30W063 AND 30W081 ESTES STREET – DREAM CLEAN / STARBUCKS ZONING

RELIEF

March 20, 2025

SUP-2025-0011

SHEET # **SP-1**

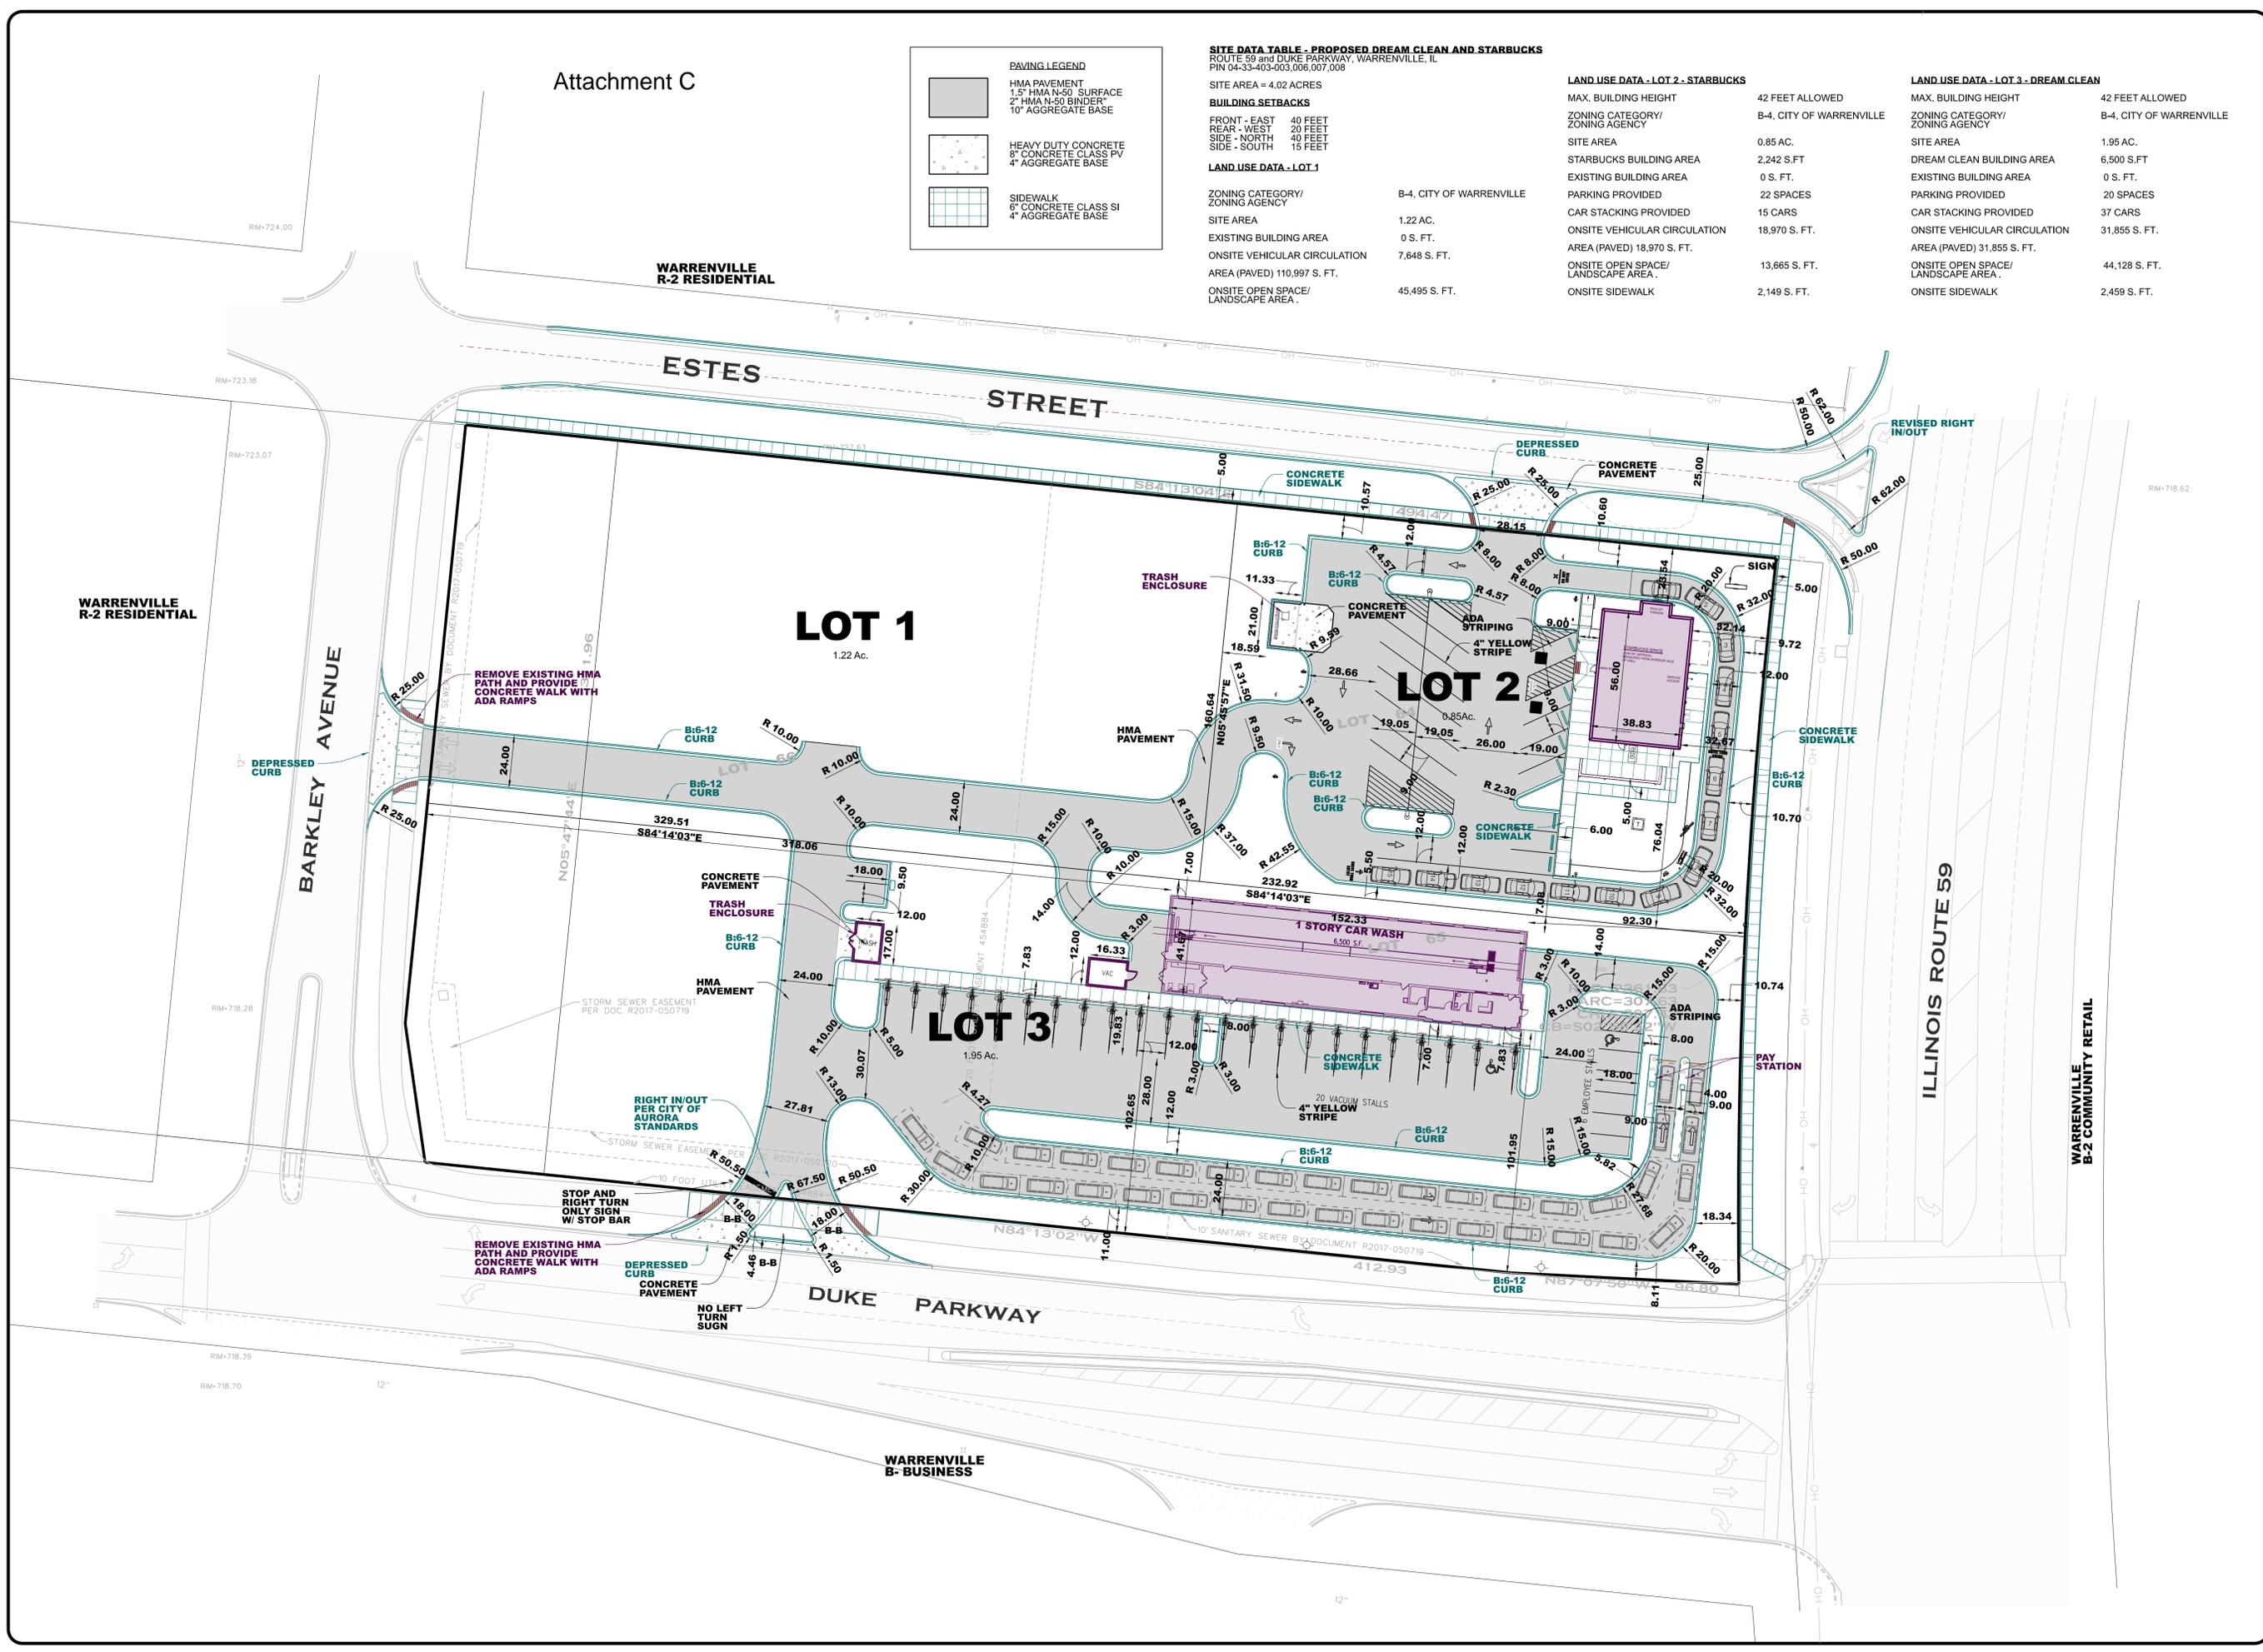
- Final engineering plans are required for final Planned Unit Development approval;
- There appears to be excess paving throughout the entire development (e.g., drive aisle width, undefined paved areas, etc.) . Staff recommends reducing pavement where possible;

- Plat of Subdivision or Site Plan shall be updated so that the lot numbers are consistent;

- The proposed landscape plan should be revised to include perimeter landscaping along the north and west property lines;
- Staff recommends narrowing the drive aisle from 24' to 22' to reduce the amount of paved surface;

- Consider removing one vacuum station from the western row of vacuums. This would result in code compliance regarding the number of parking spaces between landscape peninsulas and provide extra space to increase the size of the landscape peninsulas between parking spaces and at the east end of the row of parking;

- Consider reducing the width of the drive aisle directly adjacent to the vacuum stalls from 28' wide to the minimum required 24' wide;
- Provide data from existing locations that support the approximately 360' long queueing lane;

- Staff recommends the southwest undeveloped portion of the parcel be dedicated to a native planting garden to provide a natural amenity rather than remaining vacant.

Scale: 1"=30'
Date: 02-10-25
Sheet Name: LANDSCAPE PLAN
Sheet #: L-1

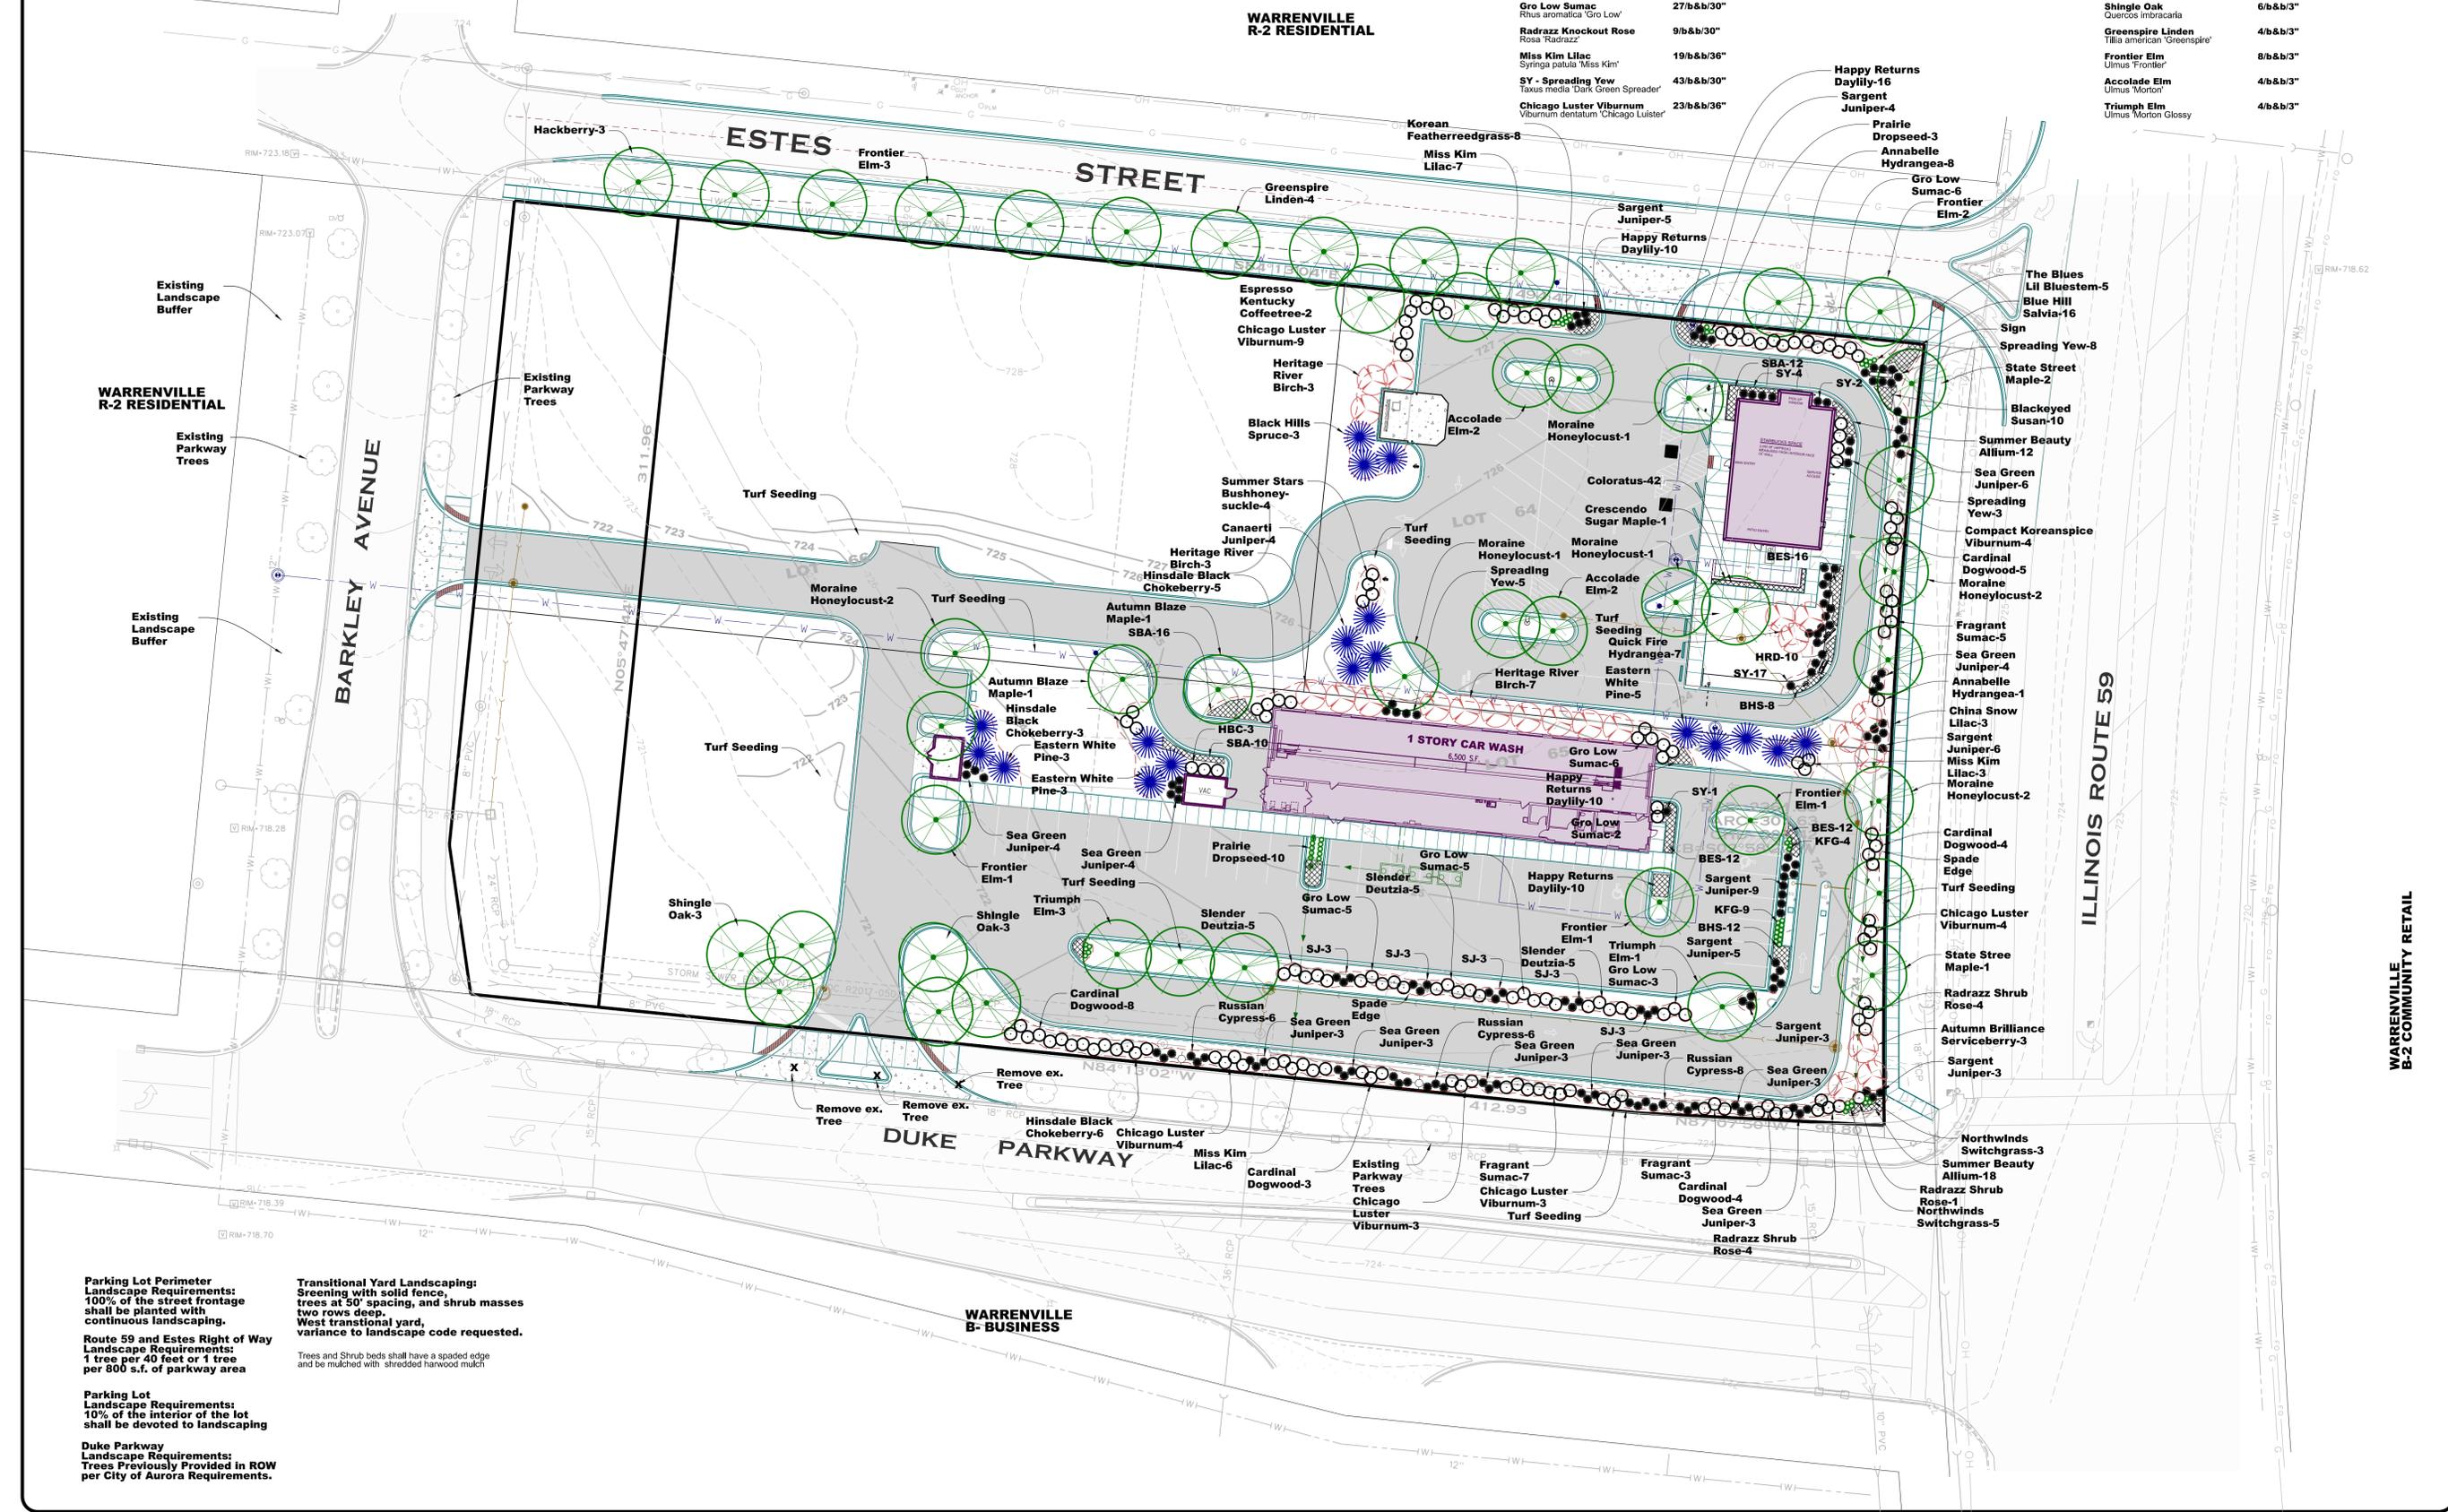
- The landscape plan shall be updated to include a maintenance plan and calendar as per 11.C.9;
- The City is considering electric vehicle related text amendments that may result in electric vehicle charging station requirements for all developments. The current amendments being reviewed by the Plan Commission would result in all developments with more than eight required parking spaces being required to install parking spaces equal to 15% of the total parking spaces for a maximum of 12 spaces; This matter will next be considered at the April 10, 2025 Plan Commission Meeting. Staff will keep the petitioner informed of revisions. While your application has been received prior to the adoption of the code, inclusion of EV charging stations is recommended.

- Landscape Plan Revisions
 - Plan shall be updated to include landscape calculations showing code conformance as per 11.C.9.
 - Not all perimeter parking lot landscaping species proposed meet the evergreen/dense shrub requirements, planting height requirement, and mature height requirement. Species shall be updated to meet these minimum requirements.

- The Applicant shall revise the landscape plan so that the perimeter parking lot landscaping includes evergreen and dense shrub species with a planting height of at least 2.5' and a mature height of at least 4';

- Consider narrowing the 9' wide sidewalk around the building to accommodate foundational landscaping and reduce impervious surface on site;
- Staff recommends additional plantings south of the patio as compensatory plantings for the required foundational plantings;

- Landscape plan revisions
 - The Applicant shall revise the landscape plan so that the perimeter parking lot landscaping includes evergreen and dense shrub species with a planting height of at least 2.5' and a mature height of at least 4';
